**STAFF RECOMMENDATION**

**2415 Oakland Avenue**

**June 16, 2021**

**Application:** New Construction—Infill; Setback Determination

**A0.0**

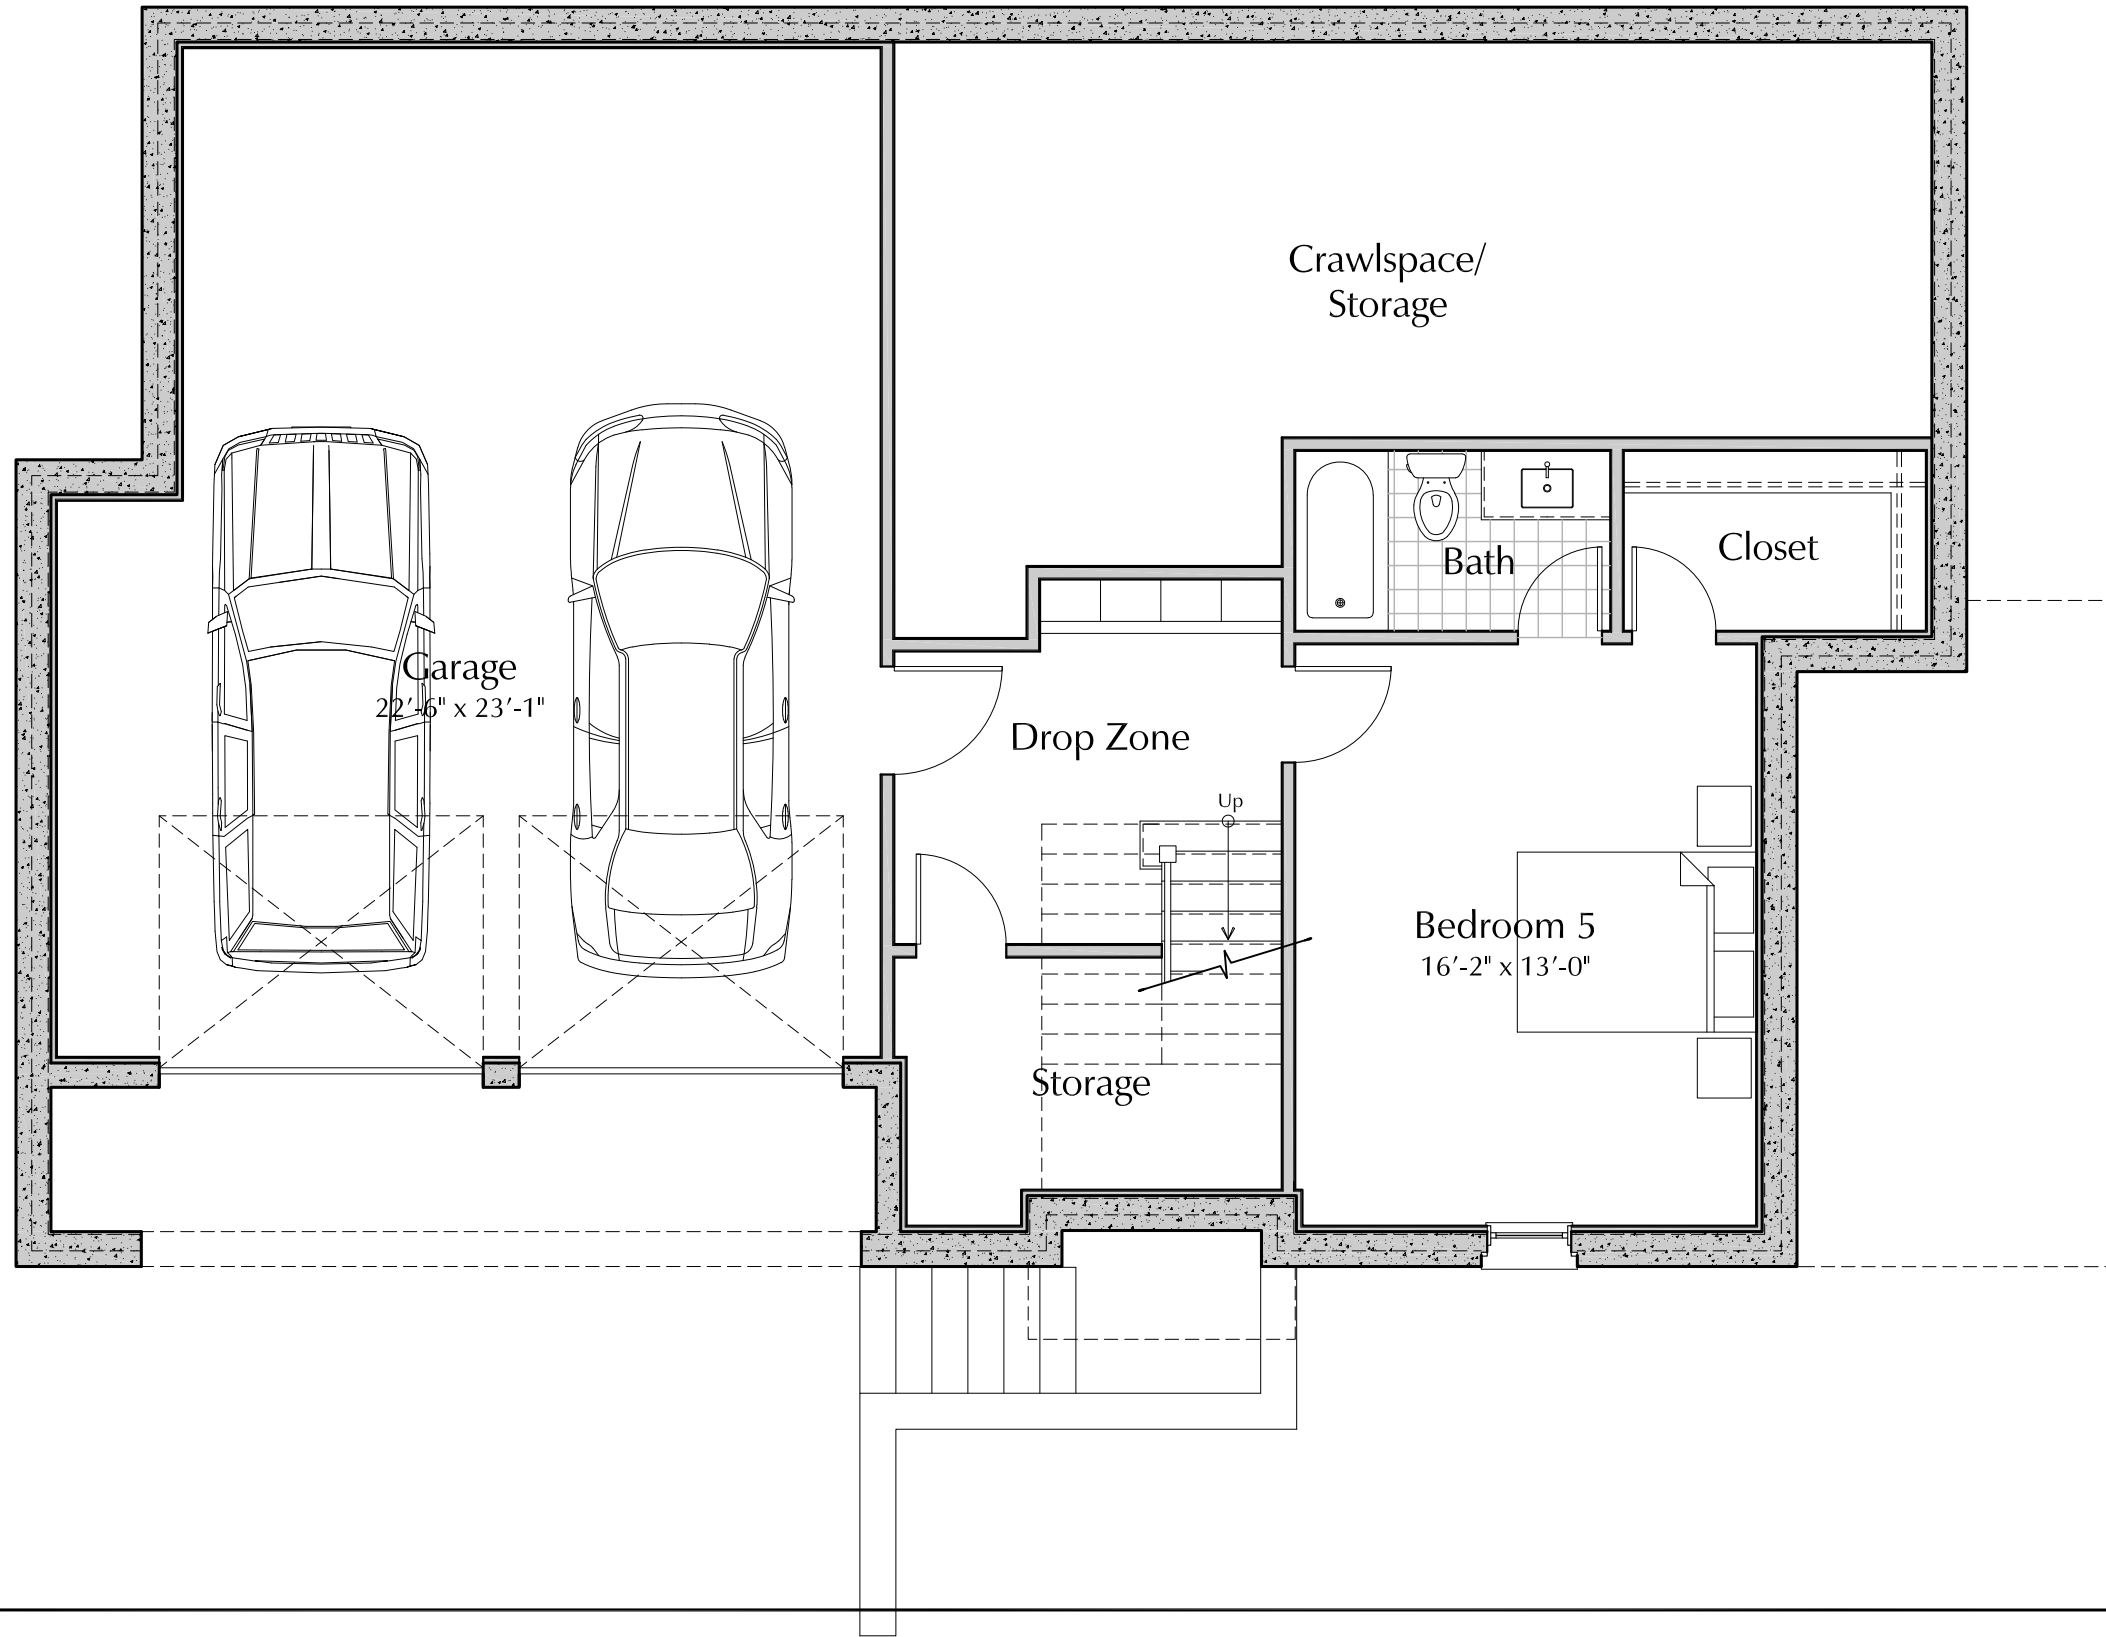
**Setback & Rhythm of Spacing:** The submitted site plan does not include the front setback of the historic house next door at 2413 Oakland Avenue. The applicant is aligning the front wall of the infill based on the existing front wall of the house that will be demolished. Since the walls of 2415 and 2413 Oakland have the same setback staff finds that this setback to meet the design guidelines and historic context. Staff will need to inspect the staking of the infill to ensure the appropriateness of the front setback. The front porch will extend beyond the front setback line by approximately four feet (4'), which staff finds to be appropriate because the porch is partial width and it will be open.

The infill meets the right side setback of five feet (5'), but requires setback determinations on the Beechwood Avenue and rear setbacks. Along Beechwood Avenue, garage doors are supposed to be 20' from the side property line, but the proposed infill will have garage doors that are fifteen feet (15') from the property line. Staff finds that the proposed setback of fifteen feet (15') for the garage doors will be sufficient to allow for vehicles to enter and exit safely from the garage without interrupting the sidewalk or street traffic.

Lastly, there is a required twenty foot (20') rear setback, but the applicant proposes a one-story porch that is just ten feet (10') from the rear property line. Staff finds that the encroachment of the one-story rear porch into the rear setback to be appropriate for several reasons. First, the lot is unusually shallow at just one hundred and fifteen feet (115'). Most neighboring lots have depths of one hundred and seventy-five feet (175'). In addition, the porch is just one story and is partial-width; it will have a width of approximately sixteen feet (16'). Lastly, the porch is pushed back from the Beechwood Avenue façade, where it will have less impact on the house behind it at 1700 Beechwood.

Staff finds the proposed setbacks and setback determinations to meet Section II.B.1.c. of the design guidelines.

1 South Elevation

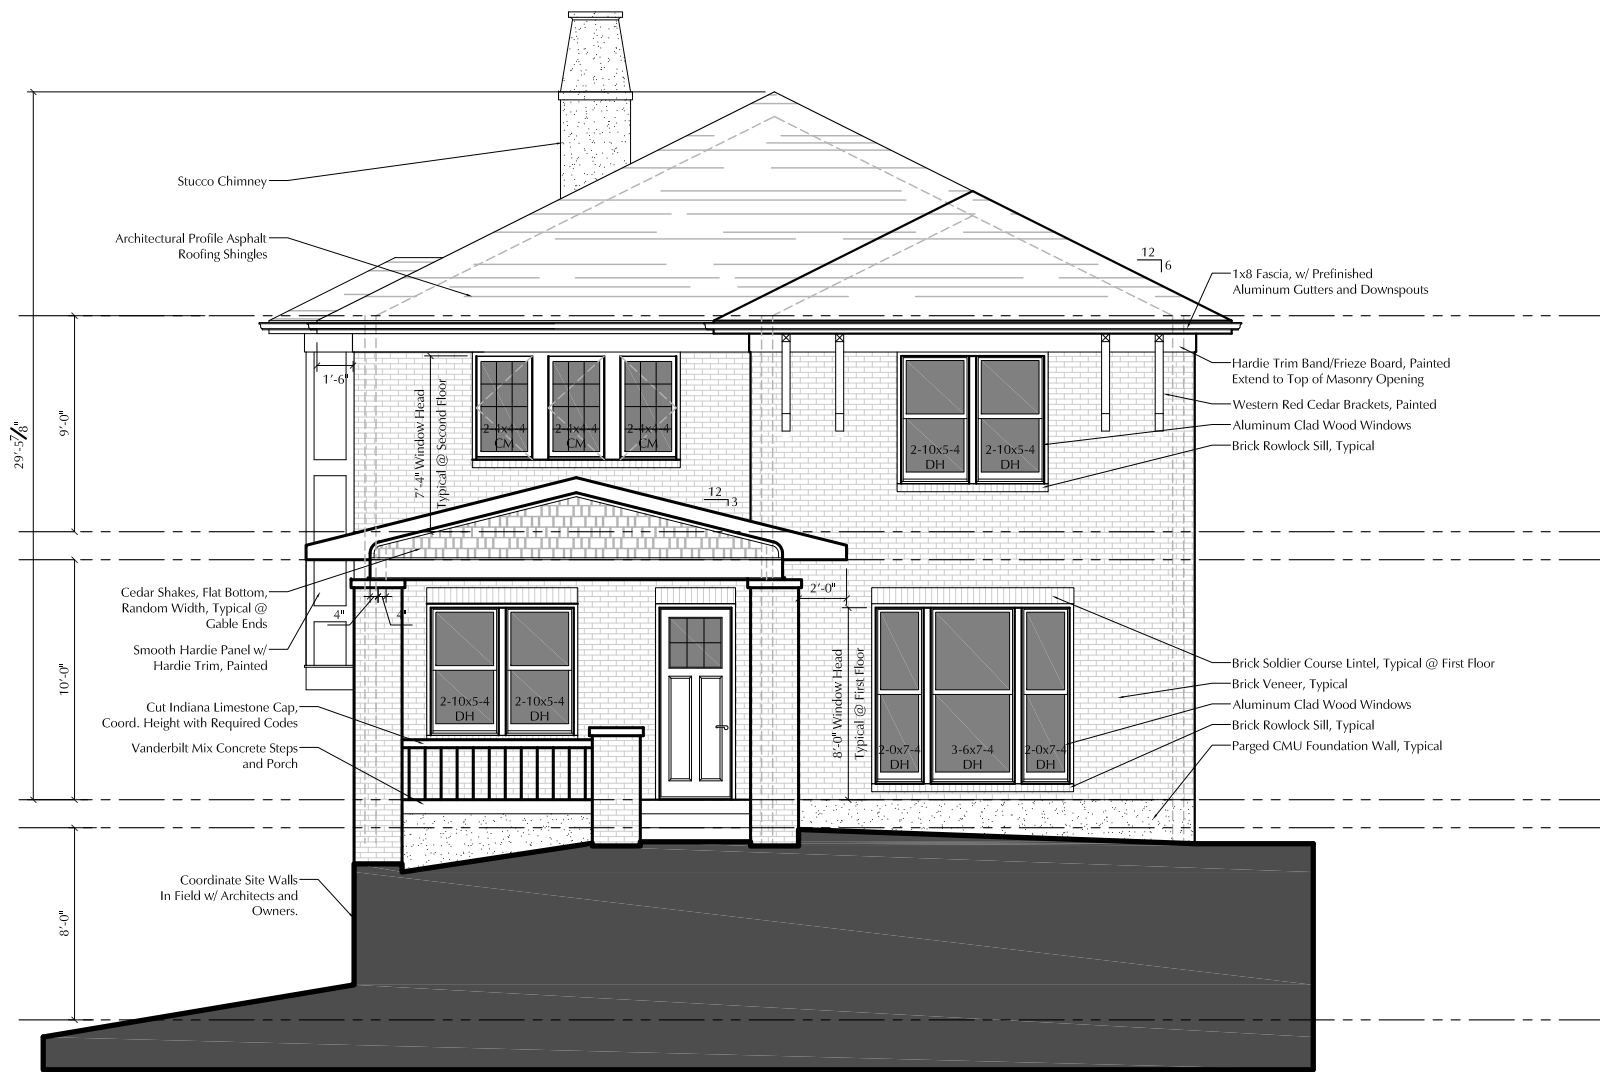
Also, along Beechwood the walls of the infill should be ten feet (10') from the side property line, but the applicant proposes a bay that is eight feet (8') from the side property line (Figure 2). Staff finds that the two-story bay's two-foot encroachment into the setback meets the historic context, as the other two-story houses on the corner appear to sit less than ten feet (10') from the side property lines. In addition, the bay is just approximately seven feet, six (7'6") wide, does not extend to the ground, and is overall modestly, scaled.

Figure 2. The front elevation showing the side bay that will encroach two feet (2') into the Beechwood Avenue side setback.

1 East Elevation

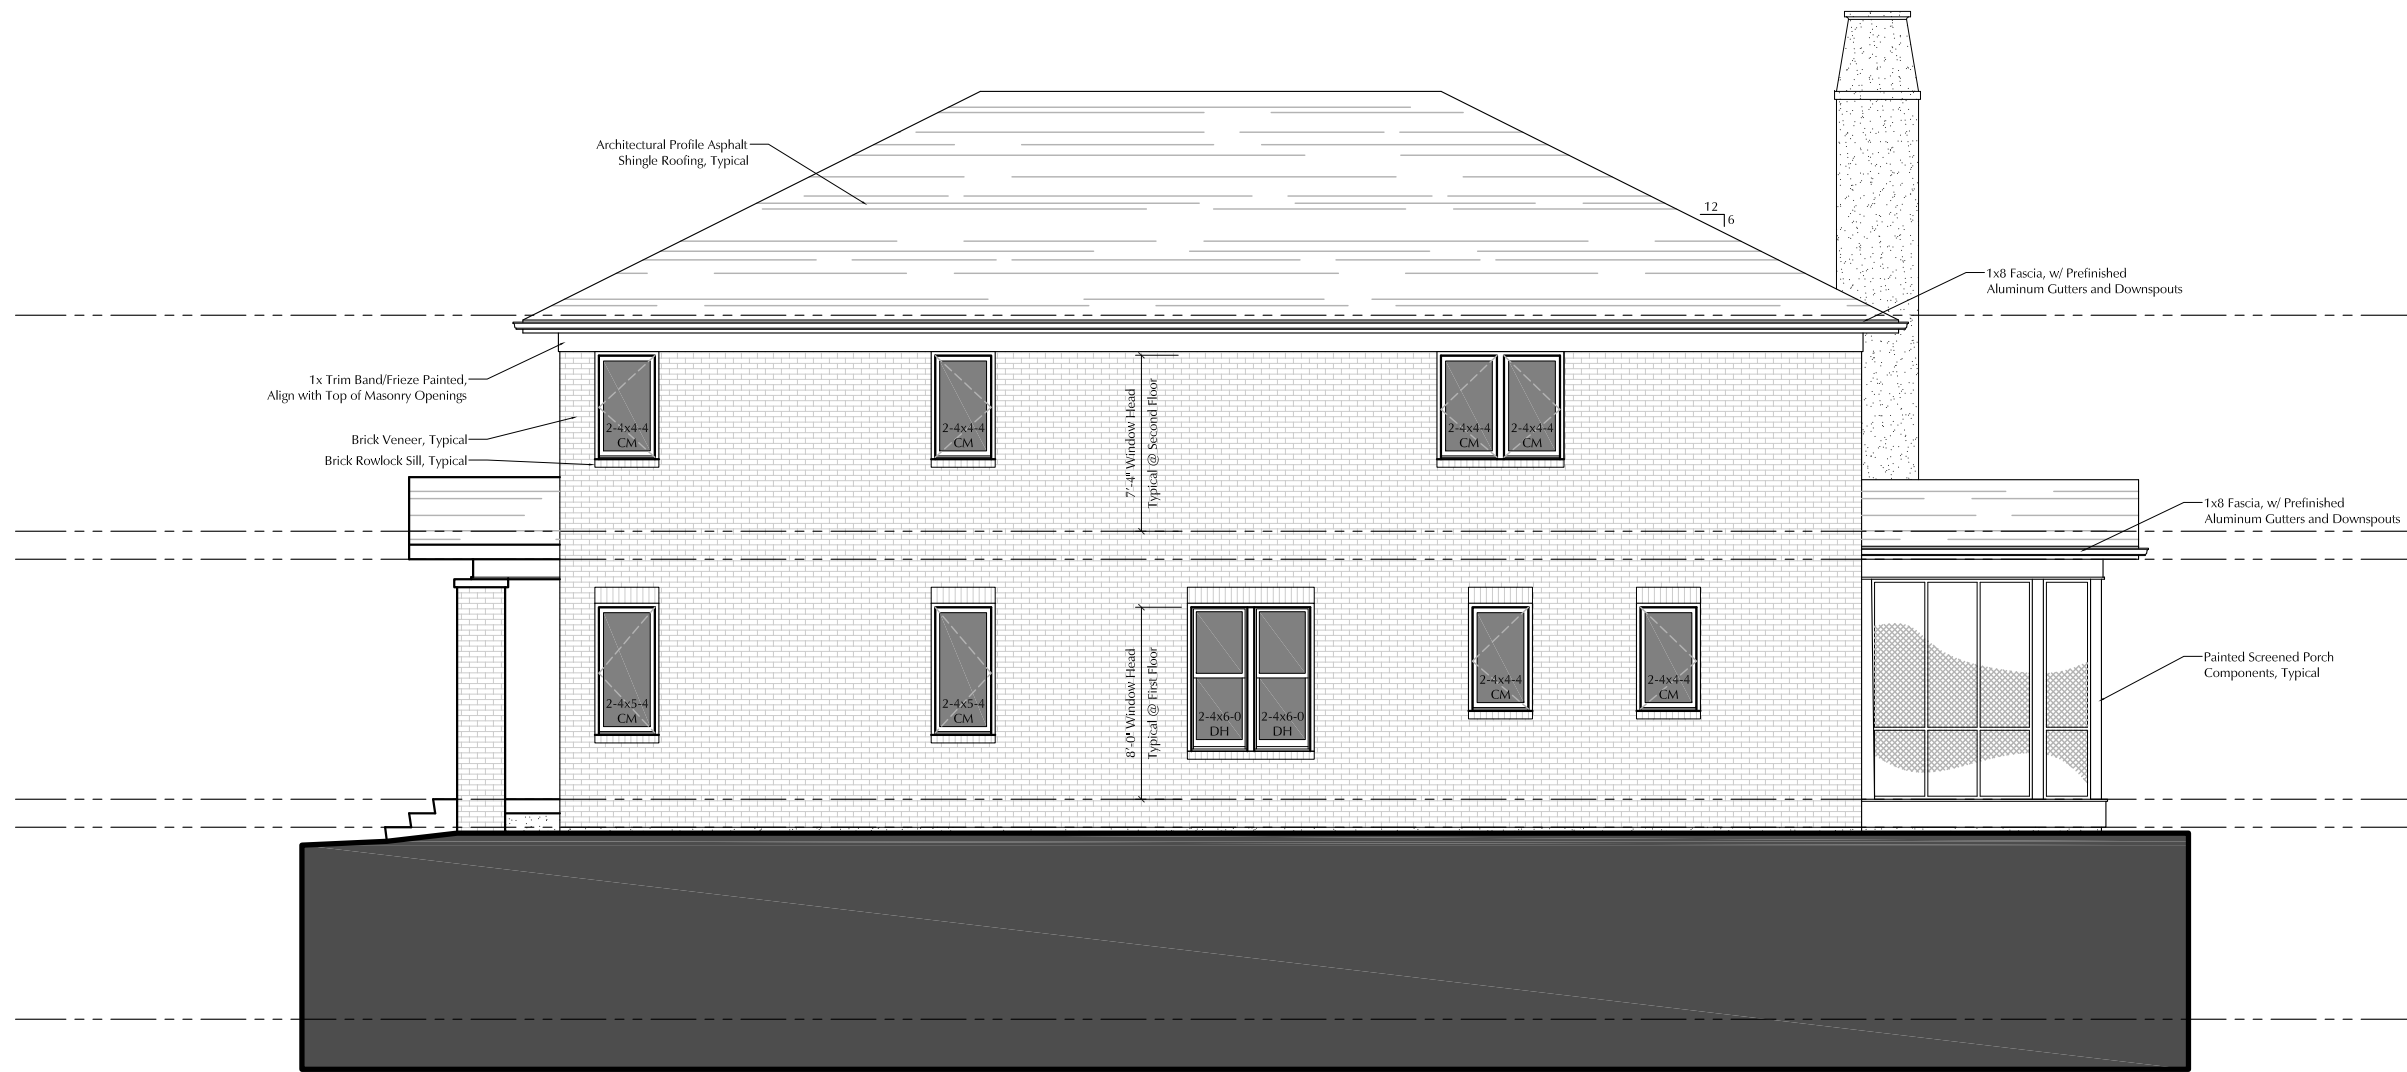
The infill includes an attached garage, located at the basement level, oriented towards Beechwood Avenue. Staff finds the attached garage and the orientation towards Beechwood Avenue to meet the design guidelines because the lot is unusually shallow and does not provide for adequate space for a detached garage. The existing curb cut will be removed and a new curb cut created to allow for access to the attached garage (Figure 3). The applicant will cut into the retaining wall and dig out part of the lot to allow for the garage to be located at the basement level.

Figure 3. The existing curb cut will be removed and relocated.
